Project Name:	Open Source OpenFrame Draft.dft
Name of Part:	OF-LL-FL-MOT

Sheet 2 OF 27
Material / Grade: Aluminium HE30

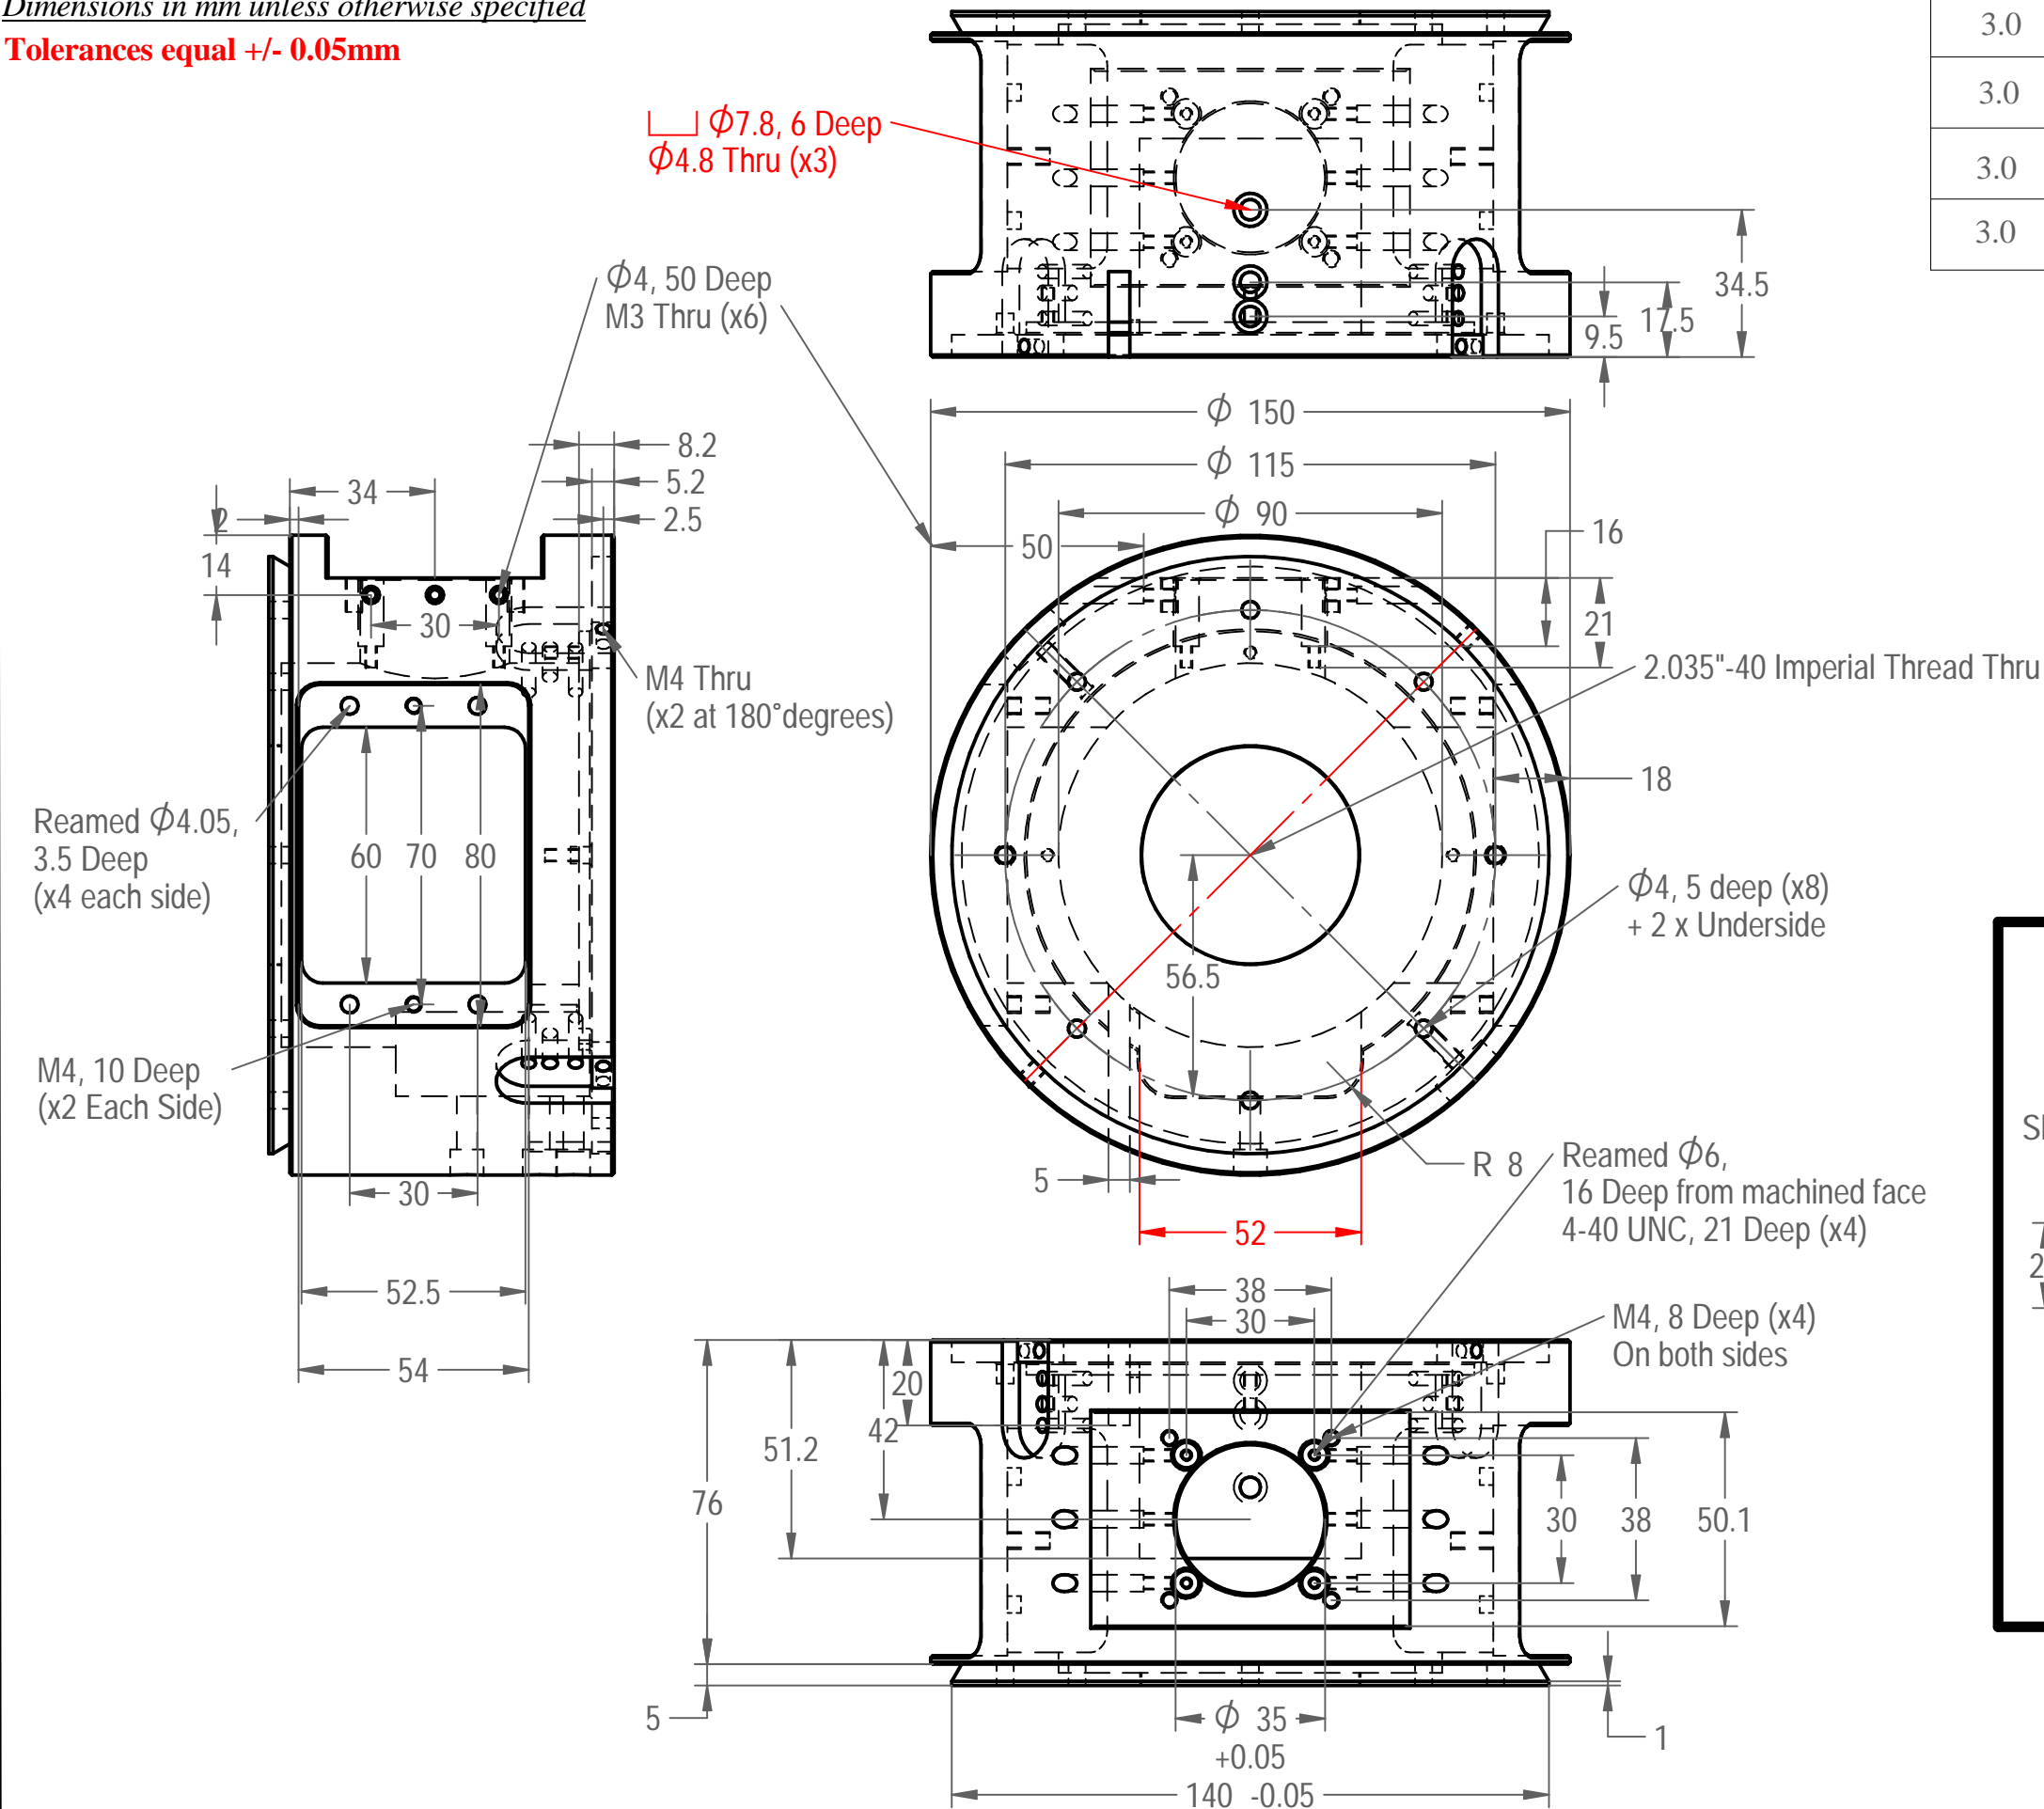
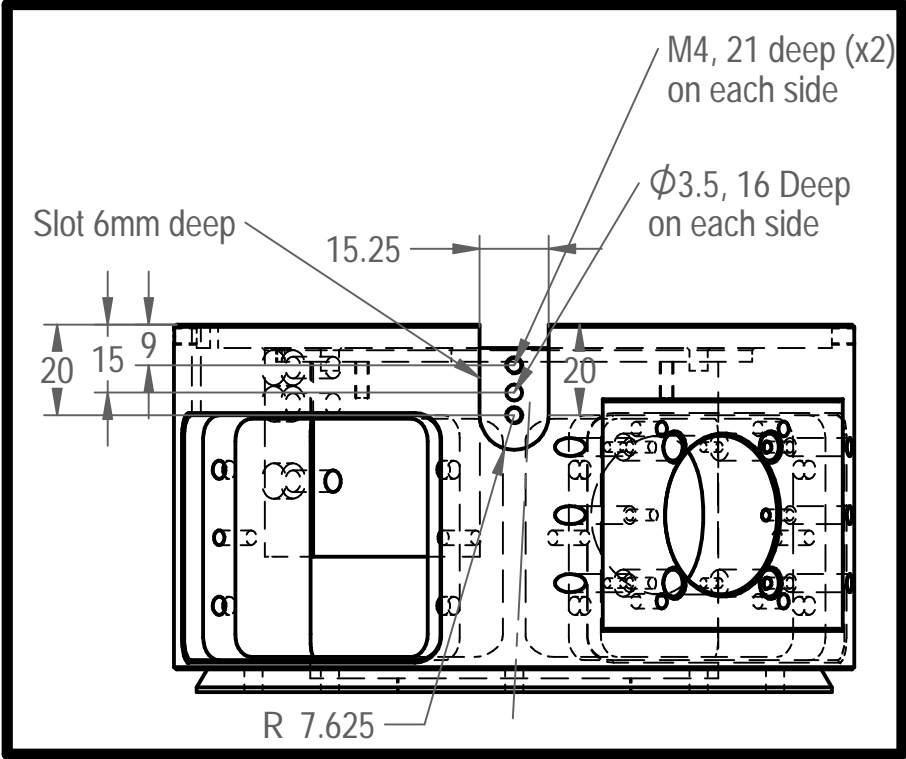
Rev. No.	Changes Made
3.0	Width of cutout changed to 52mm
3.0	Cbored Holes diameters Changed
3.0	Slots and Holes added
3.0	4mm Reamed holes changed to drilled
